SUBJECT: **AGENDA – NFPA 14 ROC Meeting (Fall 2012)**

NFPA 14 ROC Meeting (Fall 2012)

**Attachment #2:
Public Comments**

FIGURE A.7.3.2.2.1 Horizontal Exits

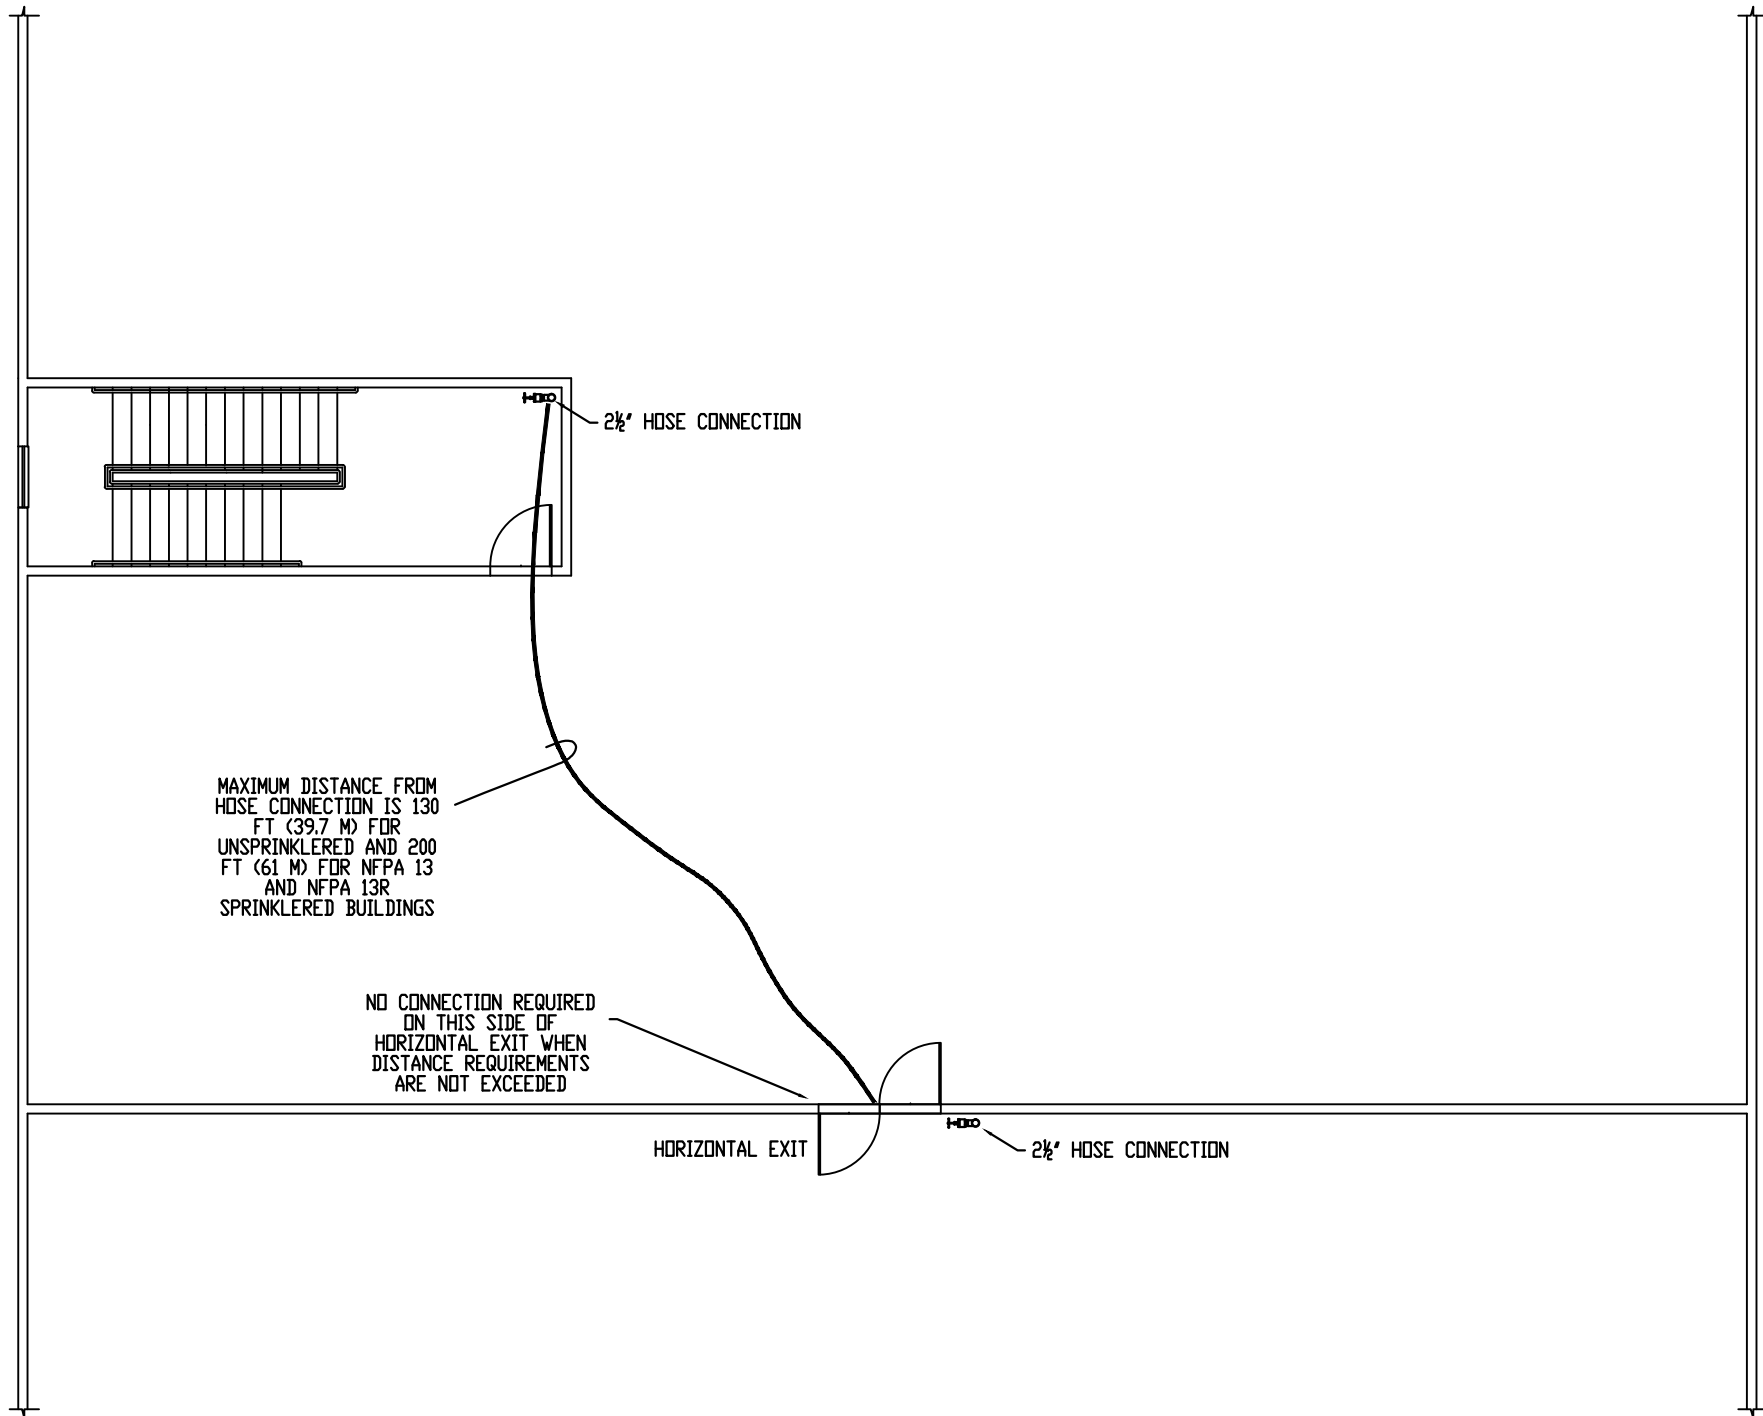
The most significant change was in regards to horizontal exits. In the ROP, there is a conflict between the adopted language of 14-48 and the wording on the annex Figure A.7.3.2.3. It is not clear as to which valve on which side of the horizontal exit can be eliminated. Does the travel distance have to extend completely through the horizontal exit and reach all areas on the opposite side of the horizontal exit? This language gives credit for sprinkler systems and eliminates connections at the horizontal exit provided that the 200 foot travel distance is met. This will be in conflict with the International Building Code at first but this is the installation standard. NFPA 14 should be dictating these requirements. The building code should only be dictating when standpipes are required, not locations of hose connections, etc. Since the building code borrowed the language from NFPA 14 in the first place, they should be synchronizing with NFPA at each code cycle revision. In addition, NFPA 14 as written in the ROP stage is in conflict already with the building code because of the allowance for 200' of travel distance. This committee is made up of experts on standpipes and writing these rules definitely falls within their purview. The exception for unsprinklered buildings (130 ft) will not appear in NFPA 14 as it does in the building code.

Delete Figure A.7.3.2.3 (14-48).

Add new Figure 7.3.2.2.1.

The most significant change was in regards to horizontal exits. In the ROP, there is a conflict between the adopted language of 14-48 and the wording on the annex Figure A.7.3.2.3. A new annex figure has been provided.

Substantiation: The proposed text (which is admittedly awkward) attempts to fix two problems. The first is that the language adopted for 7.3.2.3 in 14-48 contradicts the figure added for the annex. The text talks about omitting the outlet if you can protect on the same side of the wall as the outlet you omitted while the annex talks about omitting the outlet if you can protect on the opposite side of the wall. The latter of these two situations makes much more sense since the purpose of the outlet at the horizontal exit is to be able to fight fire on the other side of the horizontal exit.
